Staff Report

Infill Housing Design Review Committee

File Number: 10-C-23-IH

1600 N. Central St.
Oakwood/Lincoln Park Infill Housing Overlay
District

ARCHITECTURAL SITE PLAN

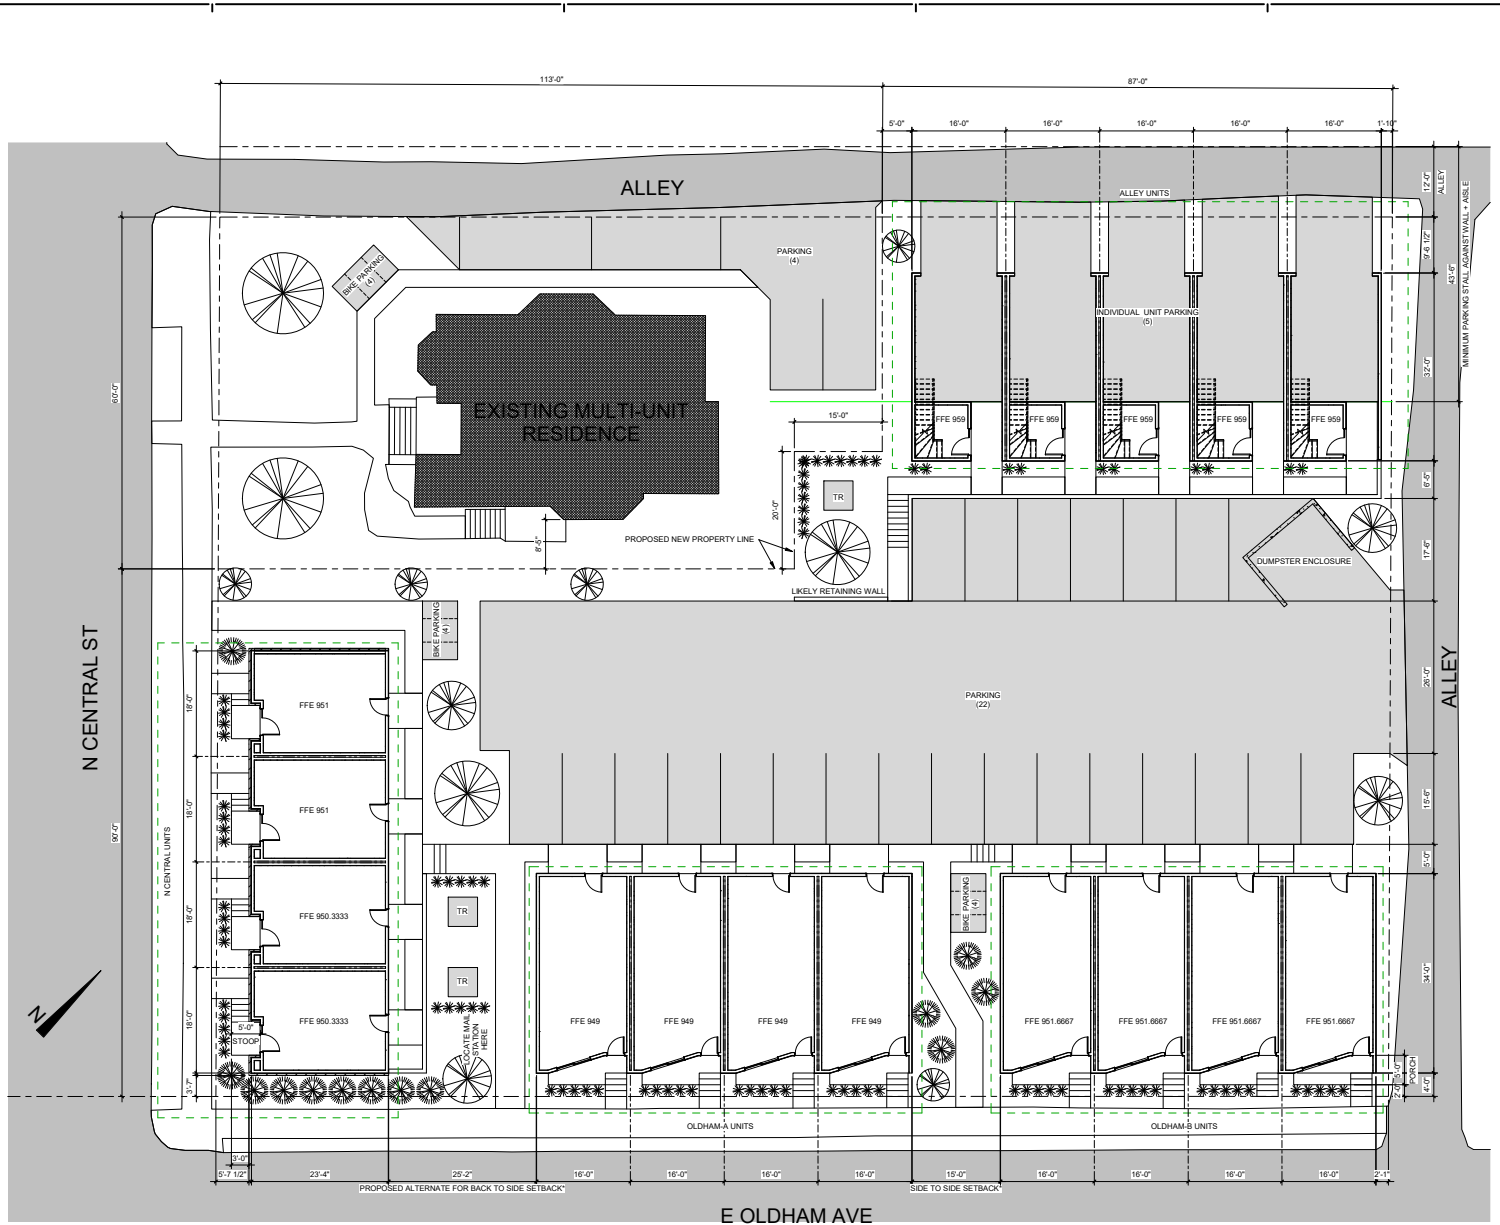
2. The C-G-2 zoning includes a 0'-20' build-to-zone as the minimum front setback and a 0'-10' build-to-zone as the minimum corner side setback. The base zoning and new housing forms will result in new construction that is significantly closer to the street than the single-family houses along the street. However, the property is a corner lot on the far west end of the Oakwood-Lincoln Park Infill Housing overlay, acting as a transition to the single-family neighborhood further down E. Oldham Ave. Placement of the townhouses on the lot is appropriate for the context. The site plan should include walkways connecting to the sidewalk.

10. The application includes landscaping elements which are generally compatible with the Infill Housing design guidelines. A final landscape plan may be required for permitting.

Pending input and additional conditions from the Board on the above items, staff recommends approval of Certificate 10-C-23-IH, subject to the following conditions: 1) final site plan to meet City Engineering standards; 2) final elevation drawings to meet design standards of C-G-2 zoning and principal use standards for townhouses; 3) rooflines on two buildings fronting E. Oldham Ave to be revised to be more compatible with the neighborhood

OLDHAM UNITS

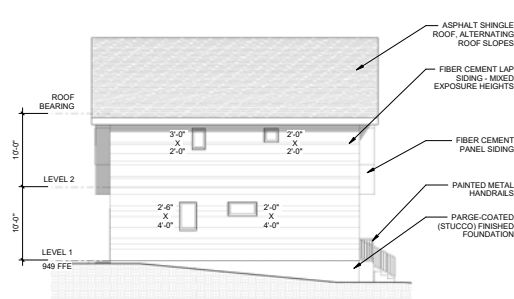
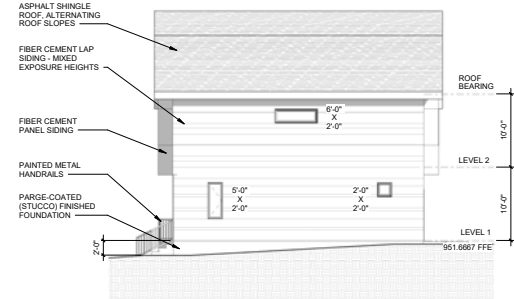
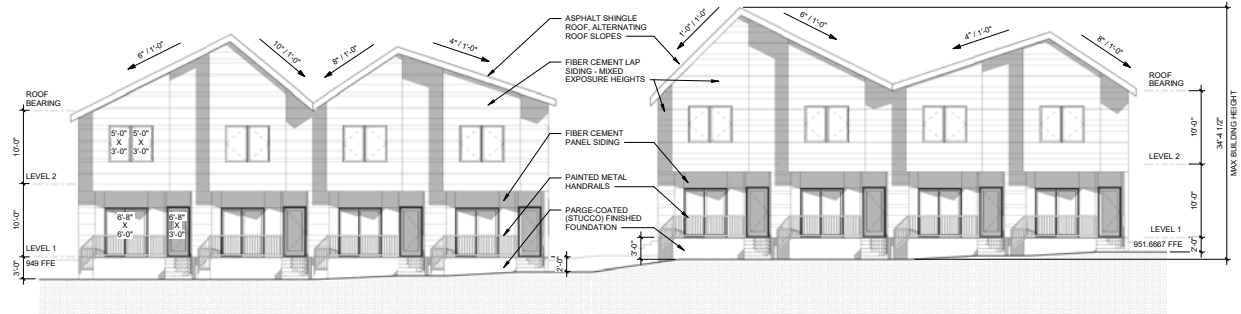
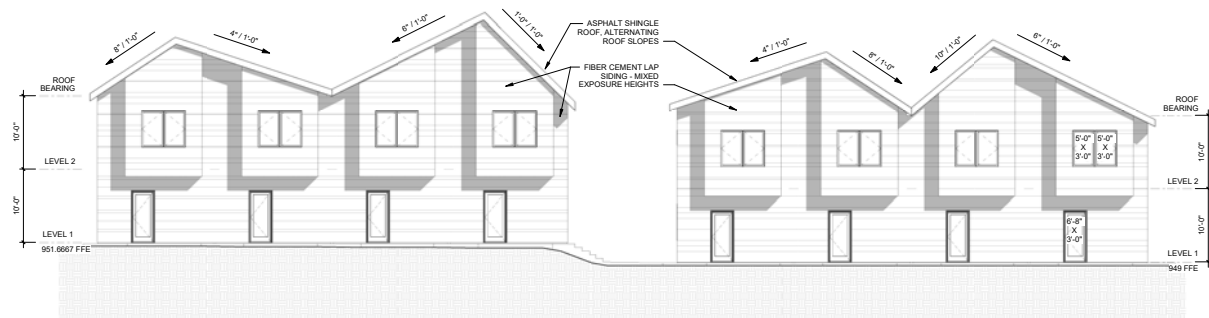
4. Guidelines recommend that "the height of the new housing be similar to the original houses along the street." The proposal meets this guideline by locating the three-story townhouse structures along Central St and fronting the alley; the buildings fronting E. Oldham Ave are two stories tall. The maximum building height is 34'-4.5", measuring to the highest roof peak. The irregularly-pitched rooflines create additional height along E. Oldham Ave. The Board should discuss the proportions of the units fronting E. Oldham Ave.

8. Roof pitches and rooflines: the Central building has comparable pitches to commercial buildings on the block. The irregularly-pitched rooflines along E. Oldham Ave are not compatible with the historic context; while incorporating multiple gable lines within each building could align the development with the various gables extending down Oldham, the irregular pitches are overly complicated and also increase the building height.

ALLEY UNITS

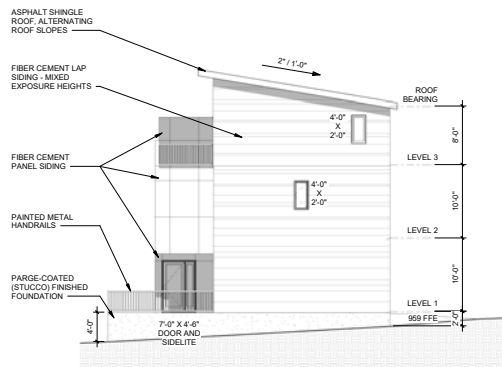
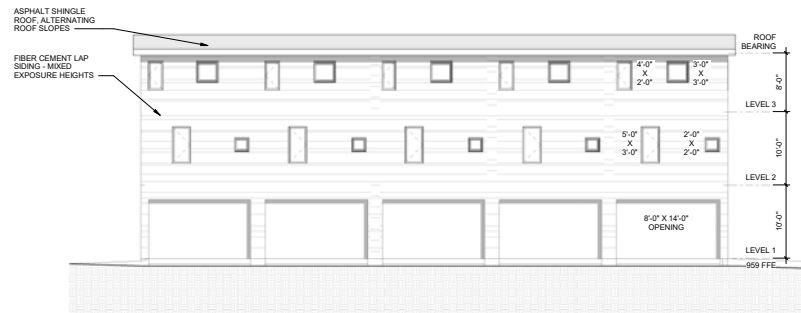
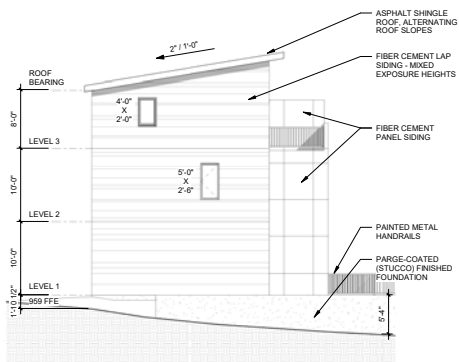
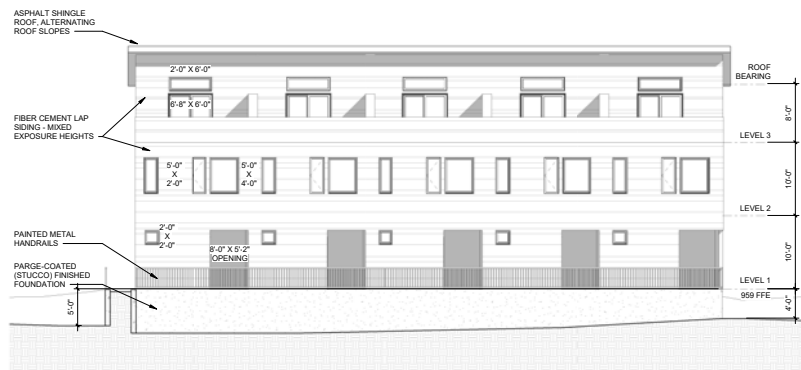
The alley units do not incorporate any bays or breaks in the façade; the doors are recessed from view and angled ways from the street. While the alley building will be internal to the site, it will be visible from the right-of-way due to its height and the site's topography. Additional design elements are necessary to align the alley building with the neighborhood context.

6. Porches: the N. Central St building incorporates projecting entry stoops; the Oldham buildings feature angled, recessed porches which are 5' deep at the deepest points and extend the length of each individual units. The alley building features one entry porch, elevated 5' above grade, which provides access to the recessed entries.

context; 4) the alley building to be revised to incorporate additional design elements to align it with the neighborhood context, with drawings meeting conditions 3 and 4 being resubmitted to the Board for additional review.
